# Interagency Aviation Safety Alert

No. IA 08-06

Subject:	Dart Aerospace Ltd Helicopter Seat 4-Point Harness
Area of Concern:	All Helicopter Operations Using Dart 4-Point Harnesses
Distribution:	All Helicopter Users

### DART SERVICE BULLETIN

Photo 2: Measurement of Buckle Latch Plate Joggle

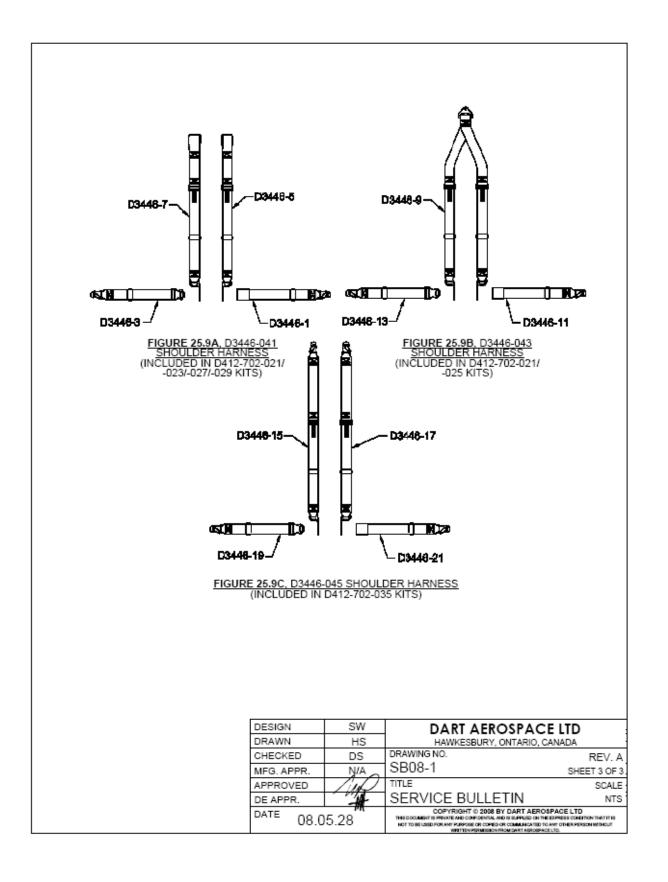
2) If the SSP code is other than "SSP1006" or "SSP1406" or "SSP3005" or "SSP1105", verify that the joggle measurement on the latching plate inside the buckle is greater than 0.210" as shown in Photo 2 below. Any buckle assembly (p/n D3446-1/-11/-21 or D3496-7) with a joggle measurement less than 0.210" must IMMEDIATELY be removed from the aircraft and RETURNED TO DART AEROSPACE LTD.
